■ **SRS AIRBAG SYSTEM**

**1. General**

► **SRS Knee Airbags** ◀

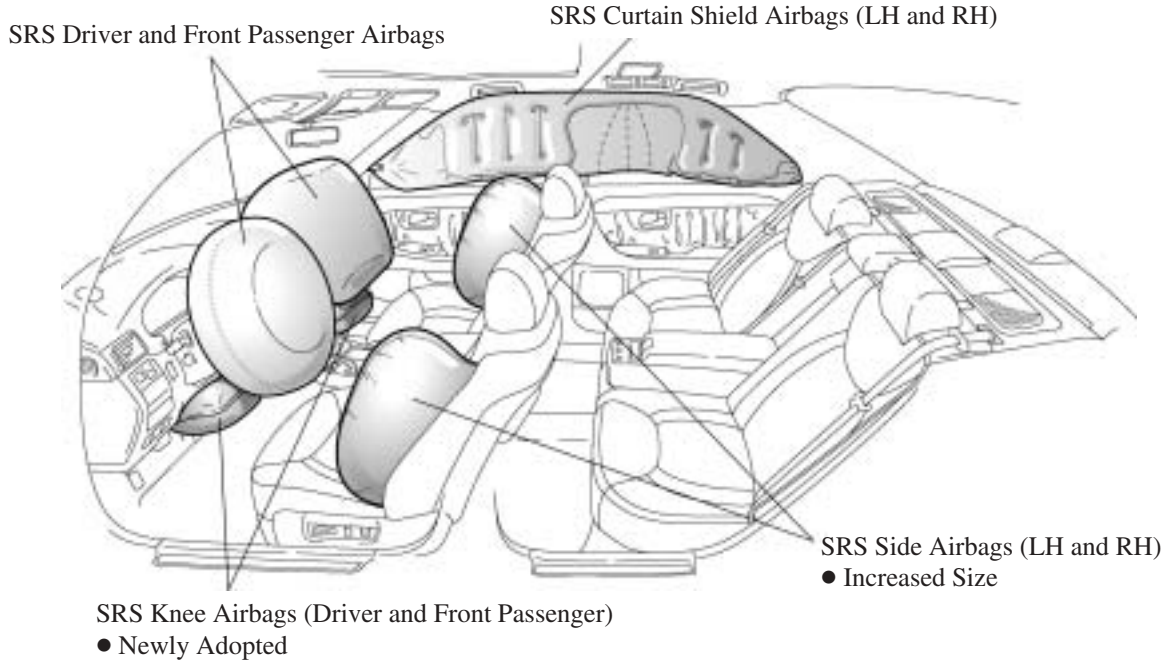
SRS knee airbags have been adopted to help reduce the shock to the driver and front passenger in the event of a severe frontal impact collision in combination with driver and front passenger airbags.

- The new LS430 has a SRS airbag system with the following equipment:

Airbag Type	New Model	Previous Model
Driver and Front Passenger	Standard	←
Knee (Driver and Front Passenger)	Standard	—
Side (LH and RH)	Standard	←
Curtain Shield (LH and RH)	Standard	←
